Determination 2010/128

Dispute over a building consent for a house with lightweight concrete panel walls at 10 Clare Place, Mt Wellington, Auckland

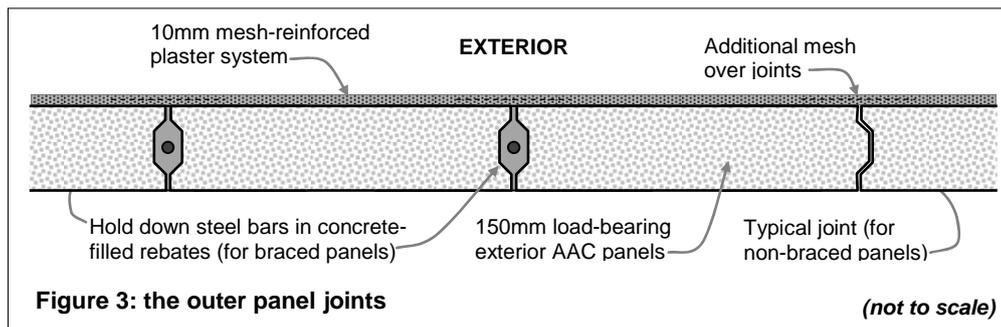
6.4.6 However, there are areas where I consider that some details provided in the application for a building consent are unclear or not sufficient to ensure the weathertightness, including but not limited to:

- details of the window and door installation, which are not accordance with the window manufacturer's recommended details for comparable concrete block or precast concrete construction, in regard to:

- window frames installed directly against the rebate, instead of set within the interior reveal with added flanges overlapping the rebates
 - because of the window position, the lack of sealants extended behind the uPVC window flanges to provide an effective seal

- the reliance on a thin bead of sealant applied after the plaster coating
 - the lack of the continuous drainage gap along the sill flange
 - the lack of a backing rod to the air seals

- the lack of clarity regarding the drip edge to the window heads
- the lack of detail regarding weatherproofing joints at braced panels
- the lack of detail on weatherproofing penetrations through the roof and walls

- 6.4.10 Providing the matters noted in paragraph 6.4.6 are resolved to the satisfaction of the authority, I have reasonable grounds to conclude that the AAC wall system proposed for this building will be weathertight and durable when installed in accordance with good trade practice.
